DOCKETED	
Docket Number:	25-OPT-02
Project Title:	Prairie Song Reliability Project
TN #:	270152
Document Title:	Jacqueline Ayer Comments - Comment letter from Save Our Rural Town
Description:	N/A
Filer:	System
Organization:	Jacqueline Ayer
Submitter Role:	Public
Submission Date:	5/21/2026 4:50:30 PM
Docketed Date:	5/21/2026

Subject: Supplemental Comments by Save Our Rural Town (SORT).

Reference: AB-205 Application Submitted for a Proposed Battery Energy Storage Project in Acton, CA.
Docket Number 25-OPT-02.

A More Detailed Analysis of the Developer’s Risk Assessment and AERMOD Results Pertaining to HF Concentrations.

Figure 1.

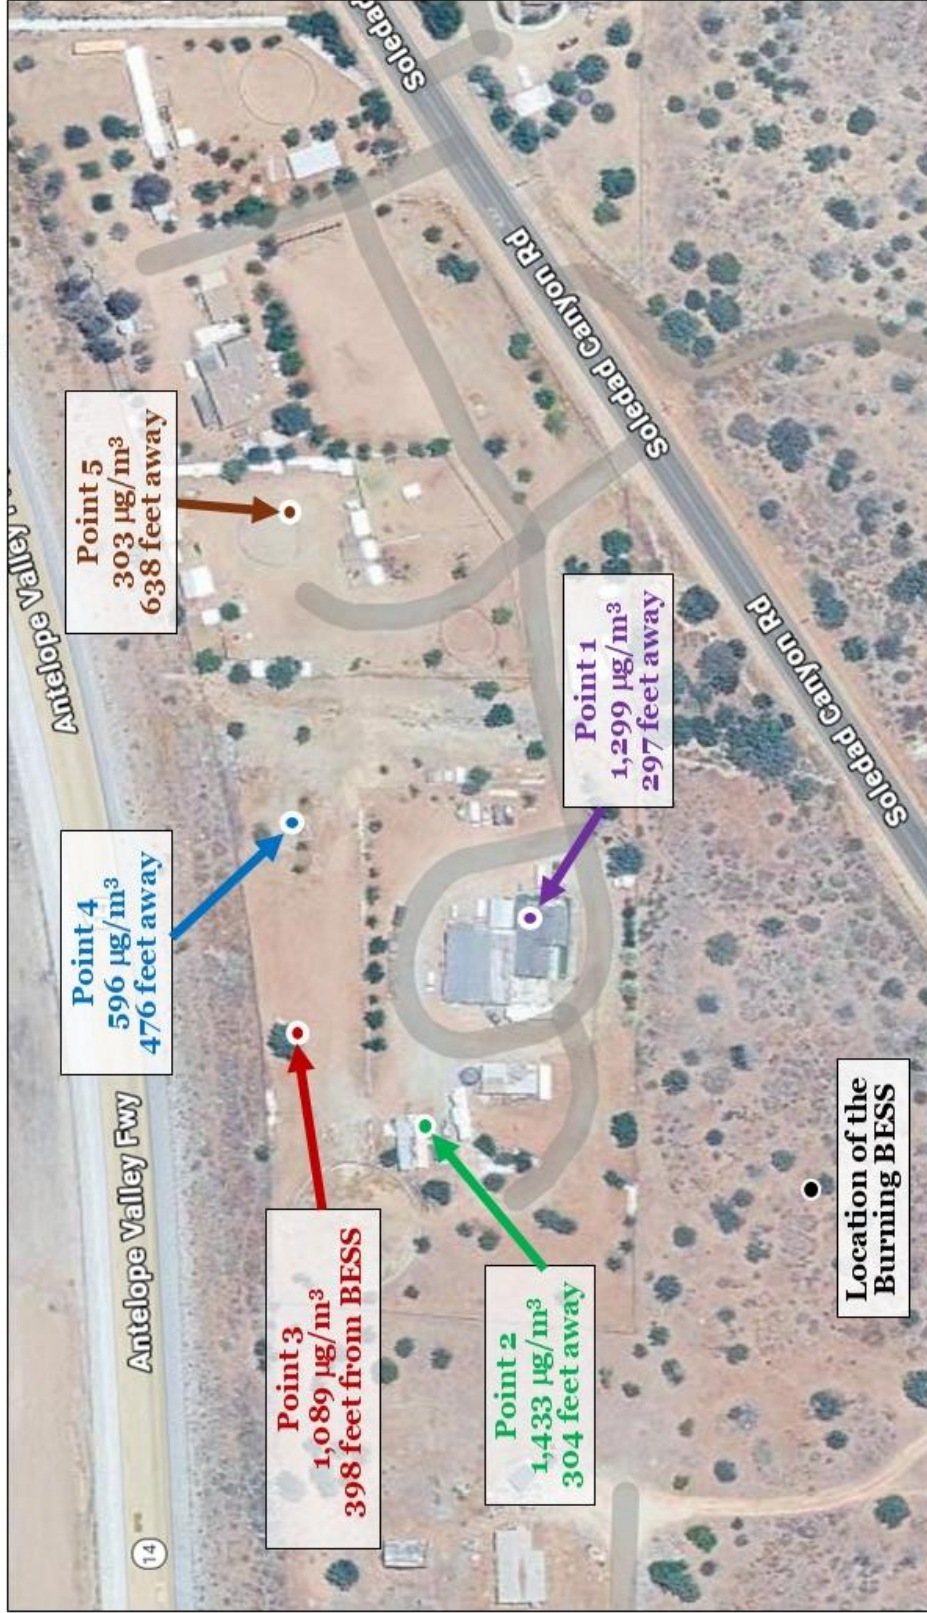
These results also indicate that, when reasonable HF release rates are applied to the AERMOD results, many locations exceed the AEGL. To assess the extent to which this occurs, SORT reconciled the location and χ/Q data reported on pages 949-950 of the developer's AERMOD results⁹ with the more reasonable HF release rates described above and then calculated the actual HF concentrations at these locations. The results of this analysis are presented in spreadsheet form in Table 1. They show that, at even a modest HF release rate which assumes only 5% of the fluorine in the electrolyte converts to HF, the resulting HF concentration exceeds the AEGL at a distance of 432 feet from the burning BESS; when 20% of the fluorine in the electrolyte is assumed to convert to HF, the concentration exceeds the AEGL at a distance of more than 700 feet. And, if 100% of the fluorine in the electrolyte converts to HF, the concentration exceeds the AEGL at a distance of more than 1,000 feet; this demonstrates that lithium BESS containers should never be located within 1,200 feet of a residential property or occupied area. To illustrate this, SORT plotted HF concentrations reported in Table 1 at specific points north and east of the burning BESS (based on the predominant wind direction assumed by the developer¹⁰); plots corresponding to the 5%, 10%, and 20% fluorine conversion rates are provided in Figures 1, 2, and 3, respectively. As Table

HF Concentrations at Various Locations Based on the Developer's AERMOD Results and Assuming that Only 5% of the Fluorine in the Electrolyte Converts to HF and is Released at a Rate of 1.49 grams of HF per Second.

NOTE: THE MAJORITY OF HF CONCENTRATIONS EXCEEDED THE 818 $\mu\text{g}/\text{m}^3$ AEGL.

Figure 2.

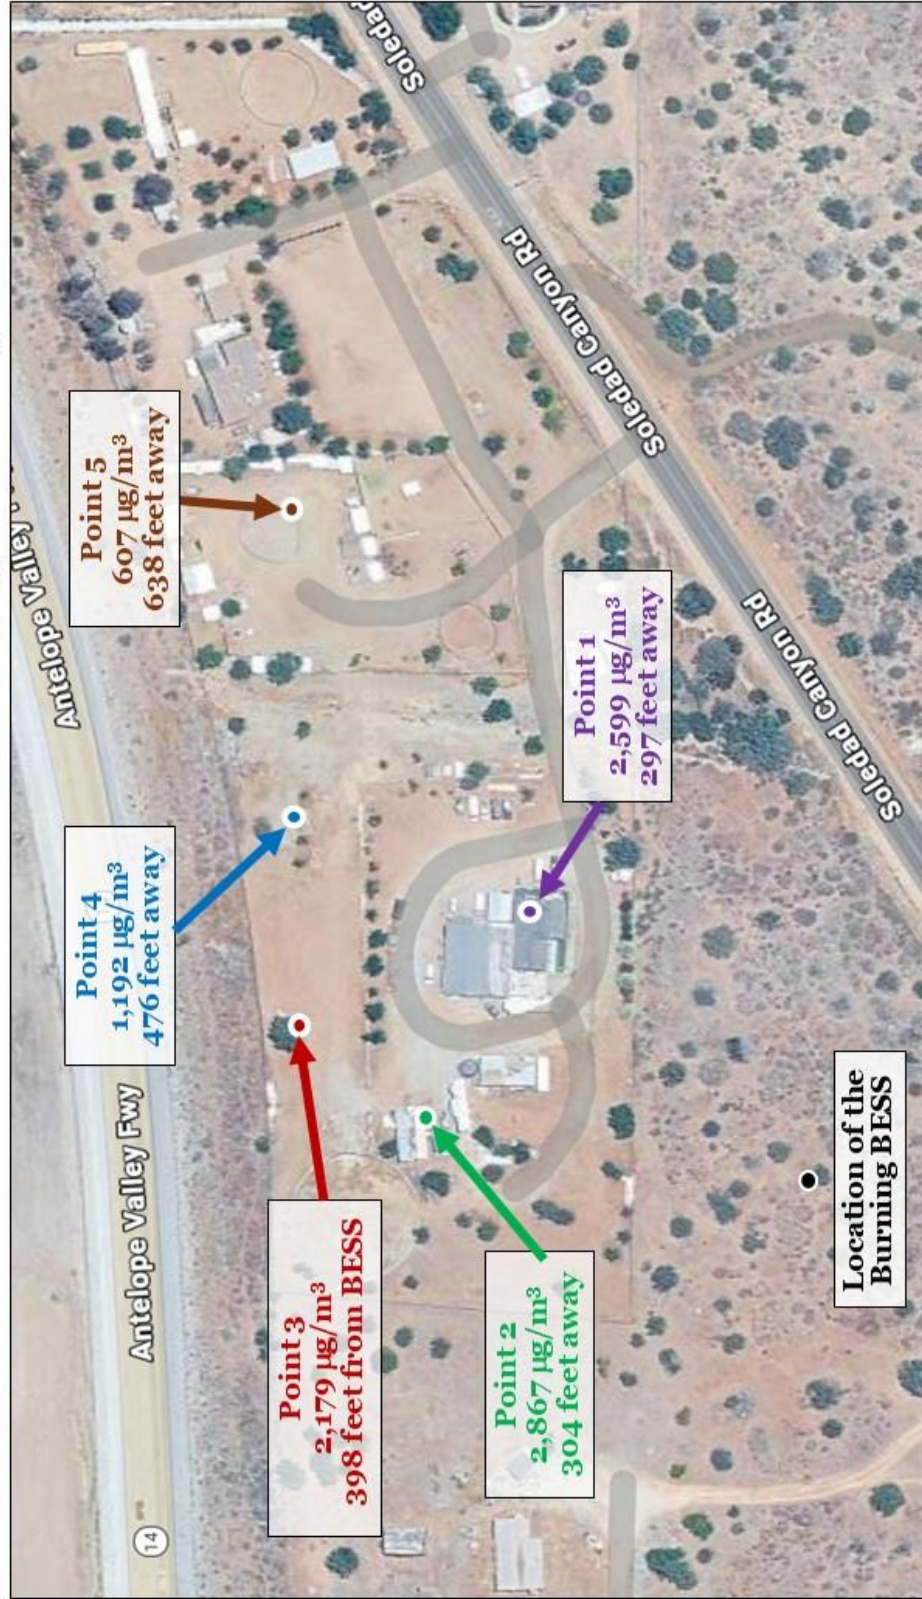
HF Concentrations at Various Locations Based on the Developer's AERMOD Results and Assuming that Only 10% of the Fluorine in the Electrolyte Converts to HF and is Released at a Rate of 2.98 grams of HF per Second.

NOTE: MOST HF CONCENTRATIONS EXCEED THE 818 $\mu\text{g}/\text{m}^3$ AEGL.

Figure 3.
 HF Concentrations at Various Locations Based on the Developer's
 AERMOD Results and Assuming that Only 20% of the Fluorine in the Electrolyte
 Converts to HF and is Released at a Rate of 5.96 grams of HF per Second.

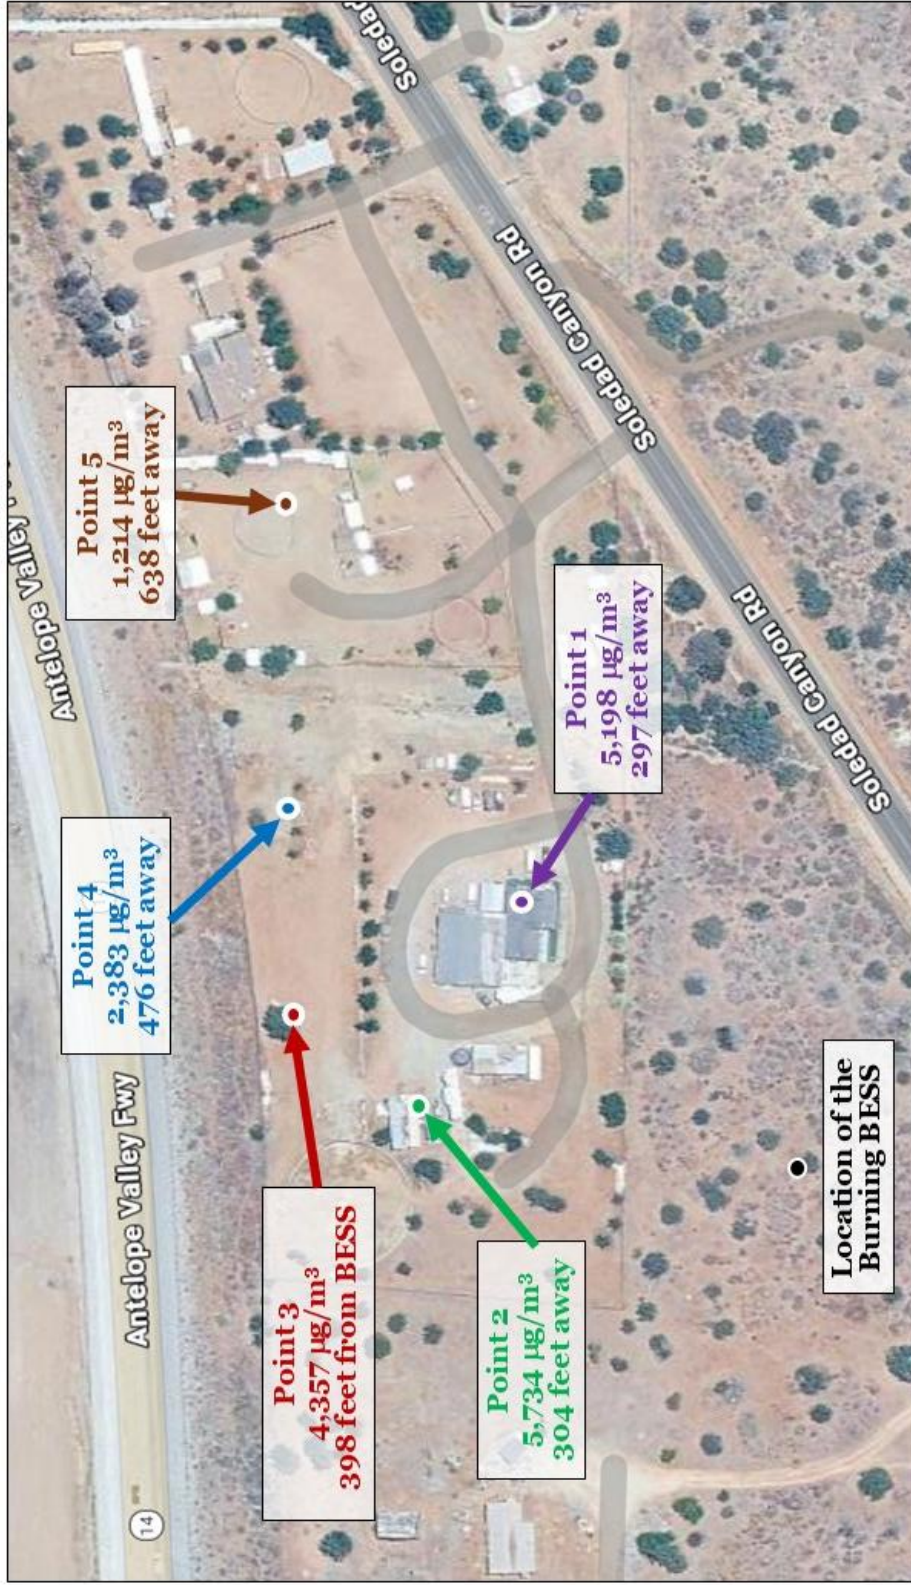
NOTE: ALL HF CONCENTRATIONS EXCEEDED THE 818 $\mu\text{g}/\text{m}^3$ AEGL.

Plotted Isoconcentration Boundary Points for ESRG Burn Test Conducted July 27, 2023

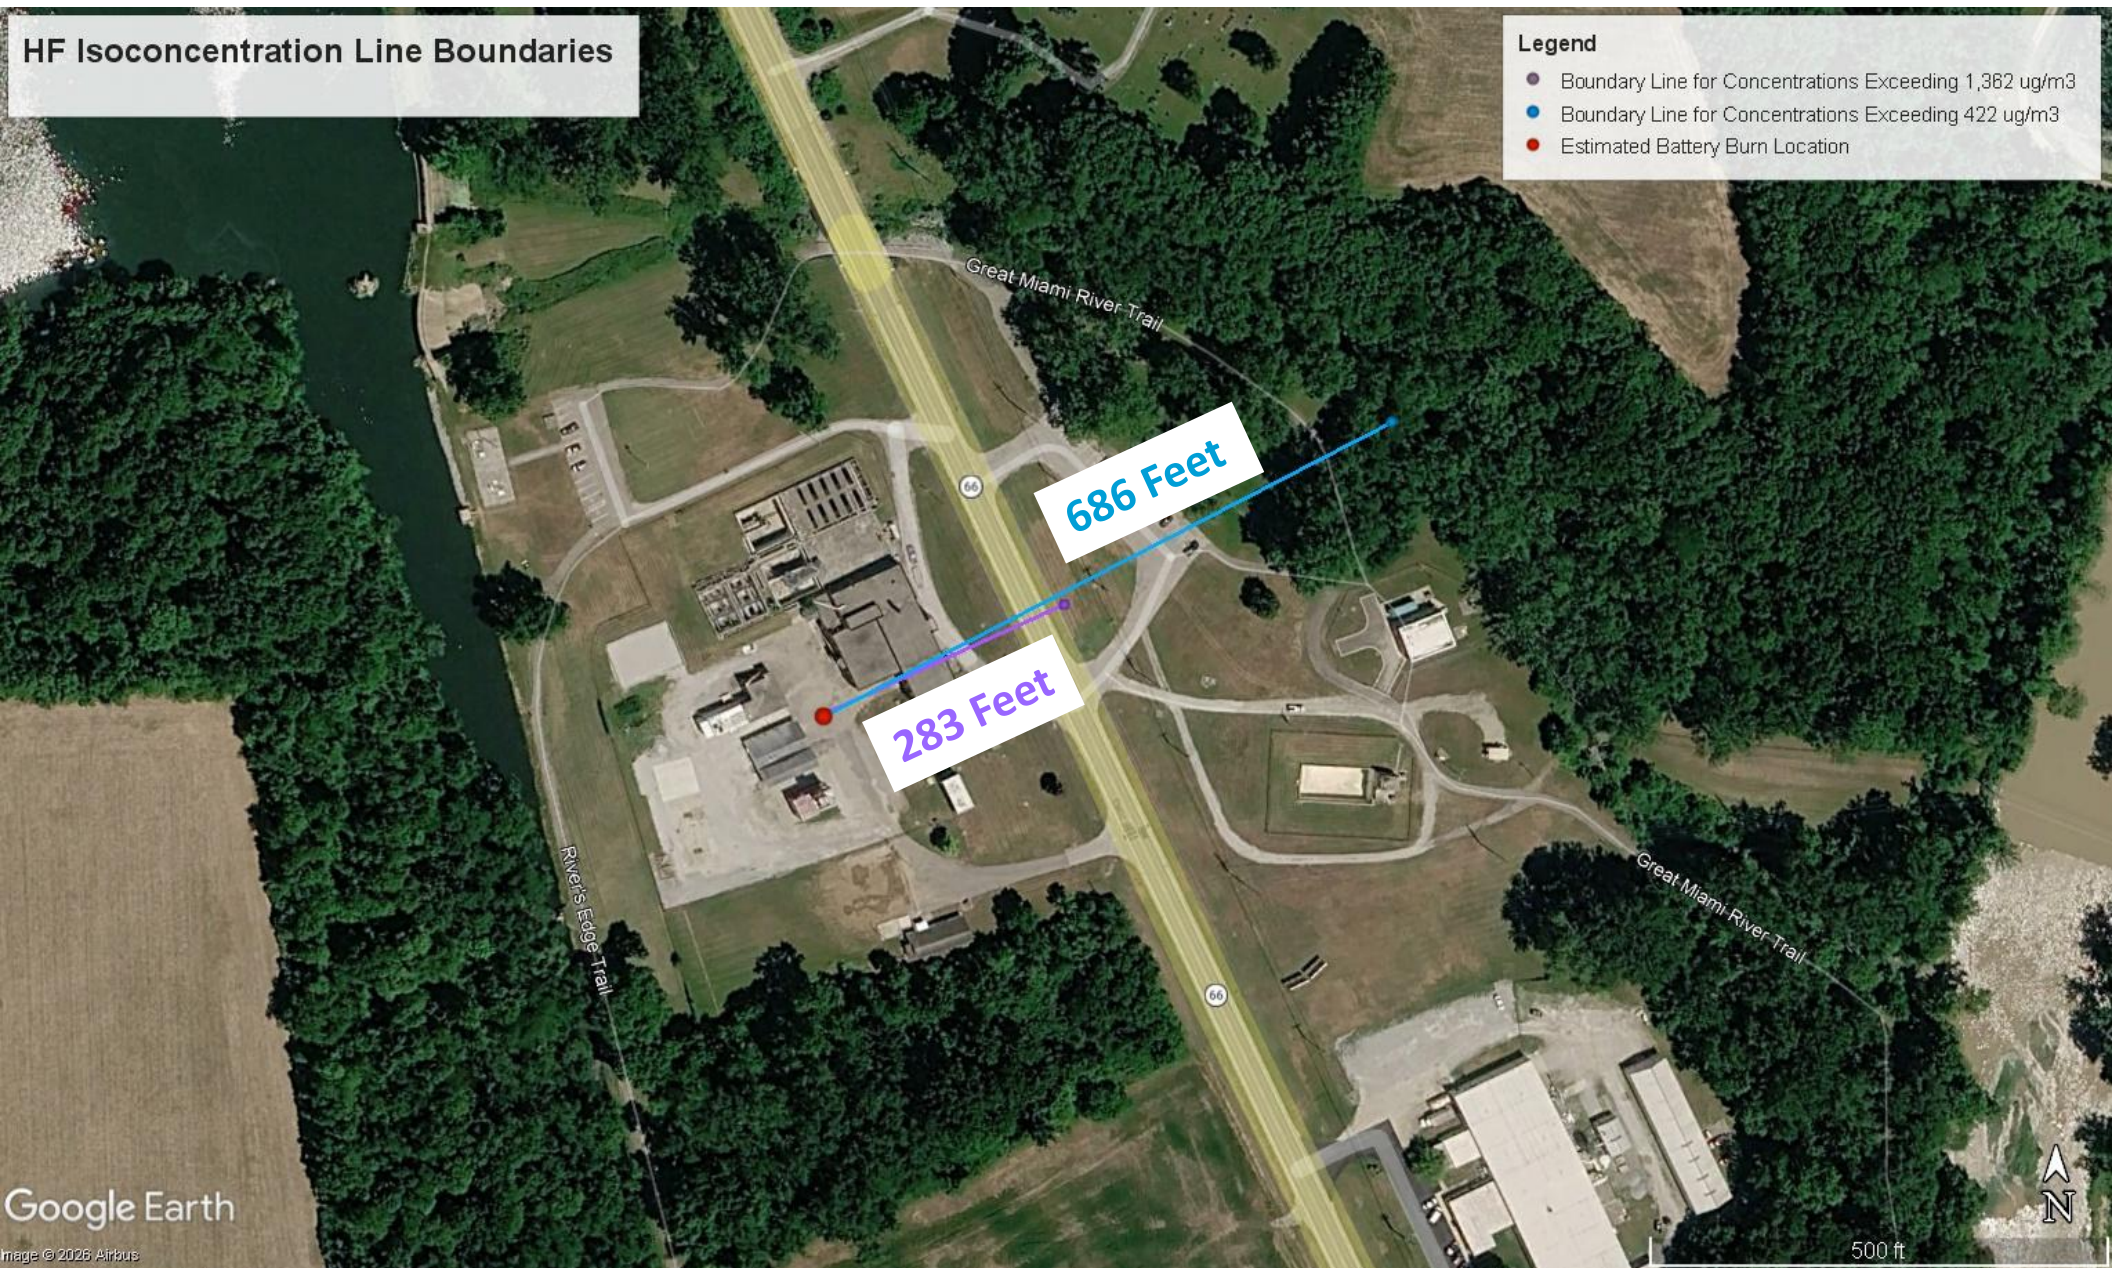
therein indicate that ground-level HF concentrations exceeded 422 $\mu\text{g}/\text{m}^3$ at distances greater than 650 feet, and exceeded 1,362 $\mu\text{g}/\text{m}^3$ at distances greater than 250 feet. The isoconcentration plots in the Ohio EPA report do not provide a scale; however, distances were ascertained using the Google Earth platform to plot the limits of isoconcentration boundaries and measure their distances from the estimated burn location. A figure showing these measurements is included in Attachment 7. The aerial images in the Ohio EPA report suggest that no homes were within 422 feet of the burn location, and presumably, unprotected individuals who were on the ESRG premises at the time were not affected because they remained upwind of the burn source. Importantly, the Ohio EPA's dispersion modeling results clearly show that HF concentrations exceeded AEGL levels well beyond 175 feet; this is relevant because Acton residential properties are within 175 feet of the proposed BESS yard. And, because the batteries burned by ESRG were smaller than a full-scale BESS container, they emitted far less HF than what will be released by the deflagration of one of the PowerTitan 2.0 BESS containers proposed for the BESS project. Accordingly, the residential properties located within 175 feet of the BESS yard will likely experience HF concentrations much greater than the 1,362 $\mu\text{g}/\text{m}^3$ predicted by Ohio EPA.
